HISTORIC AND DESIGN REVIEW COMMISSION October 16, 2019

HDRC CASE NO: 2019-570

ADDRESS: 508 MASON ST

APPLICANT: Orlando Guerrero /GUERRERO ORLANDO OWNER: Orlando Guerrero /GUERRERO ORLANDO TYPE OF WORK: Window replacement, siding replacement

508 Mason St

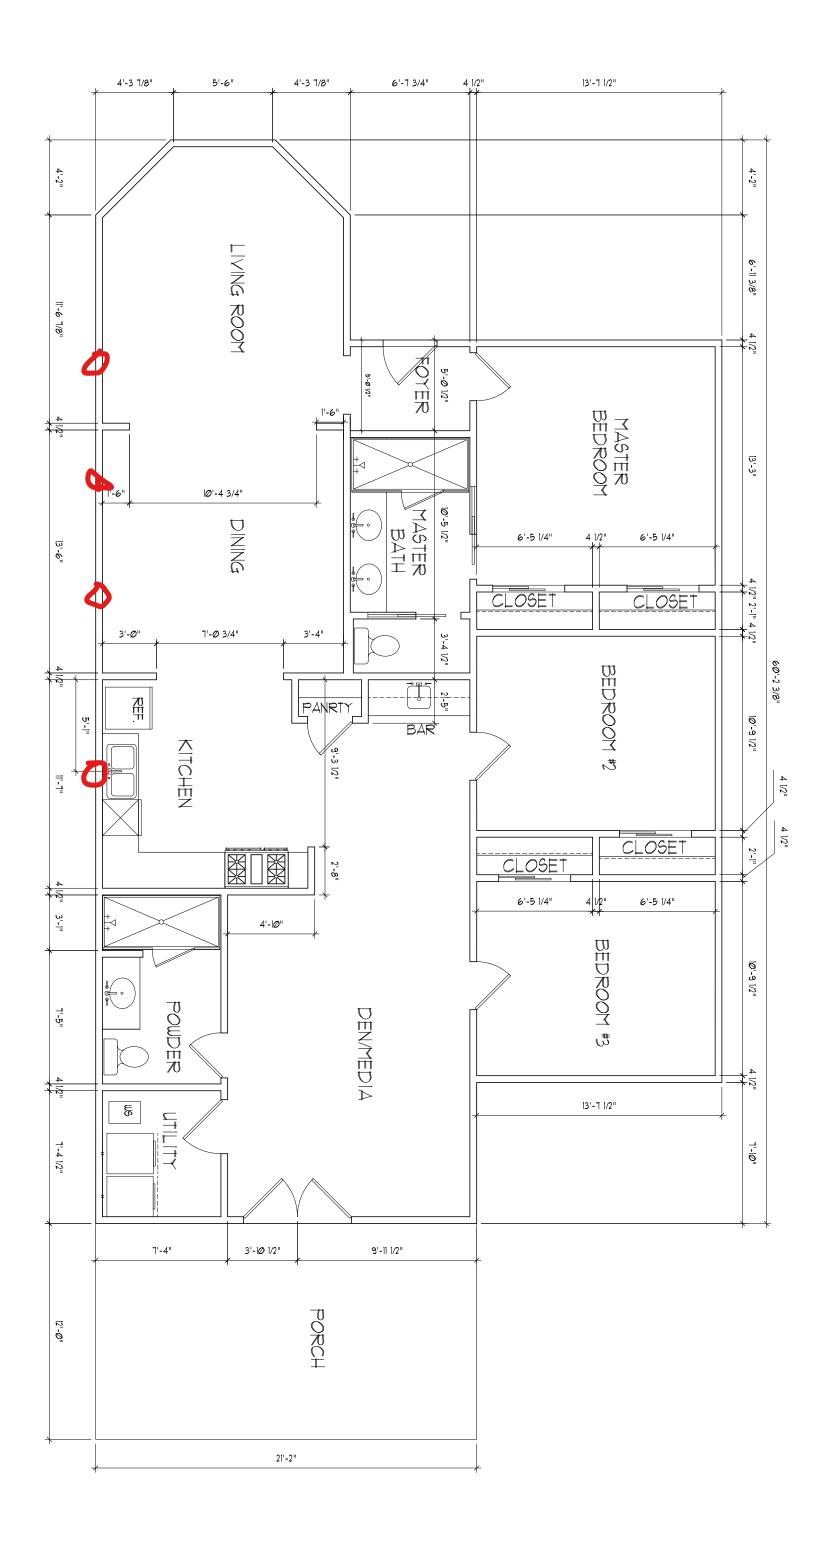
- b. WINDOW REPLACEMENT The applicant has proposed to replace the four remaining wood sash windows on the driveway side elevation to feature new vinyl windows to match the rest of the house. Per the Guidelines for Exterior Maintenance and Alterations 6.B.iv., install new windows to match the historic or existing windows in terms of size, type, configuration, material, form, appearance, and detail when original windows are deteriorated beyond repair. On a site visit on October 4, 2019, staff found the original wood windows to be in a repairable condition, and not eligible for replacement at this time. If replacement is approved, staff finds that the new windows should be wood rather than vinyl, and match the original windows in profile and installation.

- c. SIDING TREATMENT The applicant has proposed to install new siding, and plywood on top of the original wood siding to cover deterioration. On a site visit on October 4, 2019, staff found that the wood siding was in good condition, with minimal water or insect damage. Staff finds that the request is generally inconsistent with the Guidelines for Exterior Maintenance and Alterations 1.A and B. Wood siding should be repaired in-place and only replaced when beyond repair. Wholesale replacement or covering would require approval by the Historic and Design Review Commission.

- d. FISH SCALE INSTALLATION The applicant has proposed to install fish scale or wood shake shingles onto the three wall planes on the front bay window. Staff finds that the fish scale or wood shake shingles on bay windows are not typical to Folk Victorian style houses and should be avoided per the Guidelines for Exterior Maintenance and Alterations 1.B.iii.

Staff does not recommend approval of items 1 through 3 based on the findings. Staff recommends that wood windows be repaired and that wood siding should be repaired in kind. Wholesale replacement of either should not occur.
